Addendum #1 - Bid Package #6929-06

Project Name: Lincoln Public Schools District Office
5901 'O' Street
Lincoln, NE
Project No.: 11065
Issued: June 15, 2012

Sketch A14
Bid Package 6929-06
Addendum 01

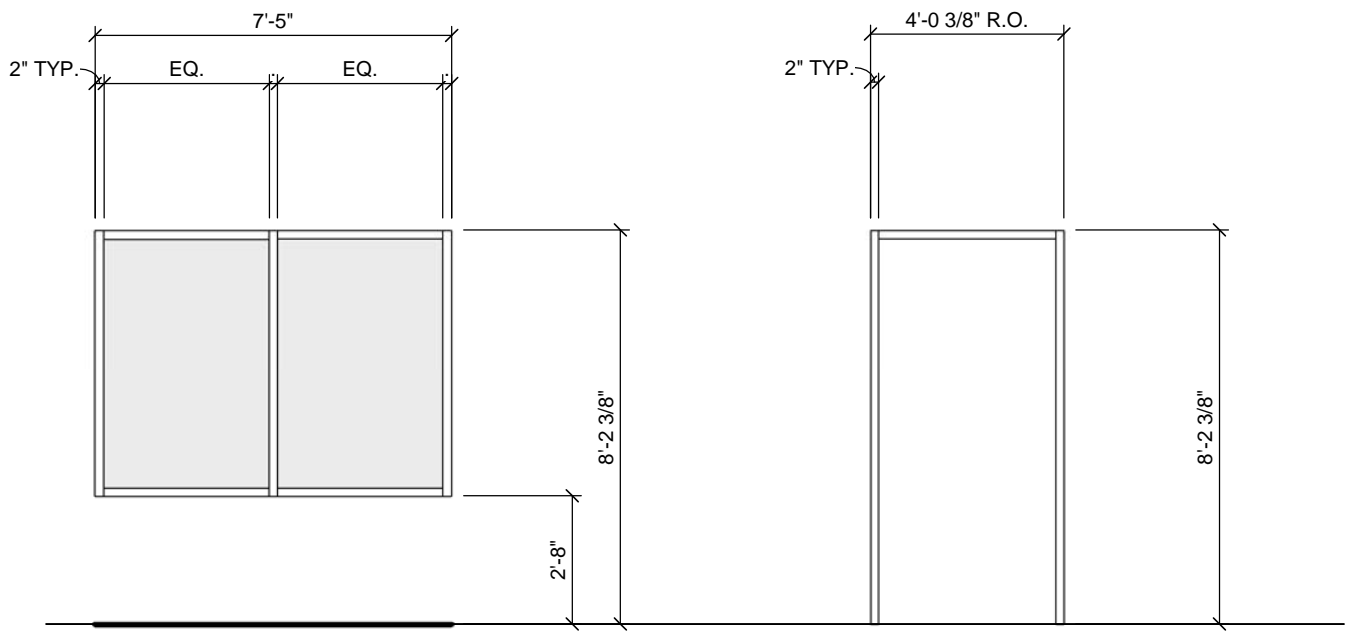
- ADD 1-40.** Add Frame Types AL44 and AL45 to Sheet A501. Refer to the attached **Sketch A14**.
- ADD 1-41.** Refer to Sheet A501, Door Schedule; Replace door schedule with attached schedule. Note the following clarifications:
